January 11, 2024
05159

**Amended Site Plan Application, Shaw Brothers Quarry
341 Mosher Road, Tax Map 31, Lot 15, Shaw Brothers Construction, Inc.**

STORMWATER MANAGEMENT REPORT

BRICKYARD QUARRY GORHAM, MAINE

SHEET 2 OF 2

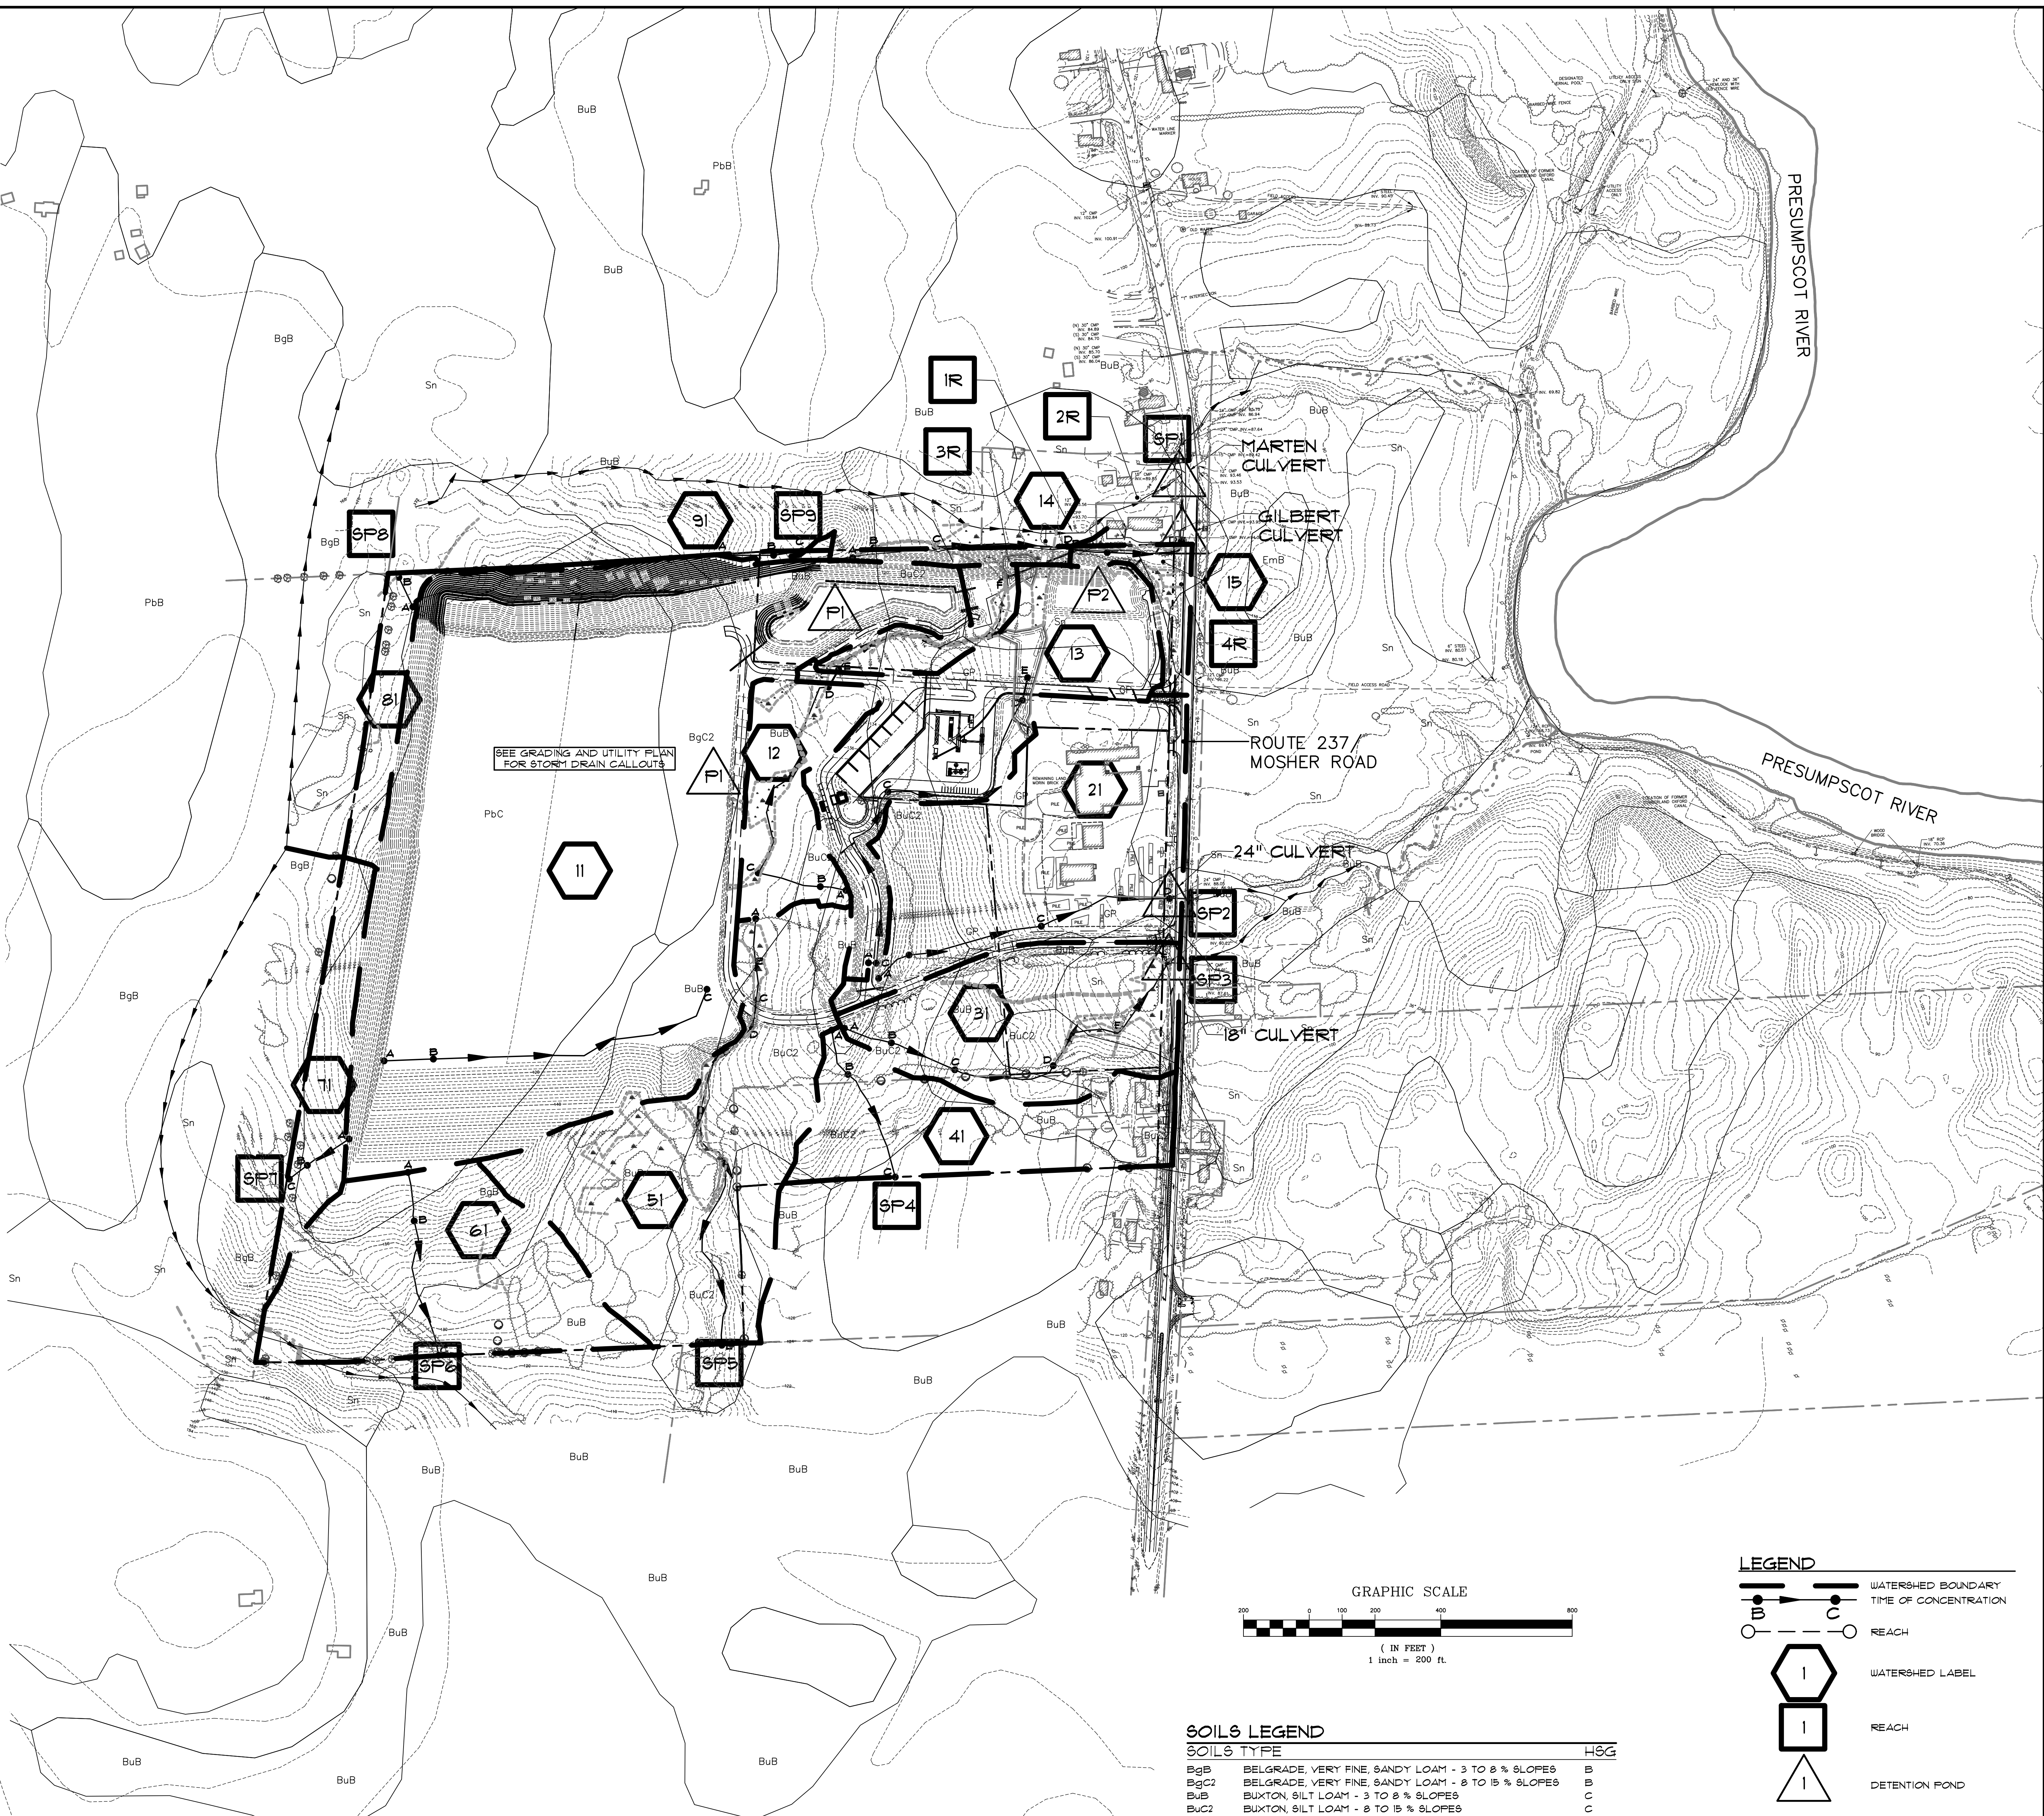
- c. Applicant to clarify how much of the impervious area is treated. There appear to be discrepancies. Please check and revise as needed. Tributary acreage to Pond 1 in post-development HydroCAD model does not seem to match Table 1 or Wetpond #1 Design. The post-development HydroCAD model shows 47.35 acres draining to Pond 1, of which 78.33% (37.09 acres) is impervious. Wetpond #1 Design sheet shows 37.39 acres of impervious area and 8.31 acres of landscaped area, which totals 45.7 acres.

Response: The proposed tributary acreage to Pond 1 is 37.09 acres. This number has been updated in the post-development HydroCAD model, Table 1 of Appendix 1, and the Wetpond #1 Design sheet to show the correct impervious acreage. A copy of Table
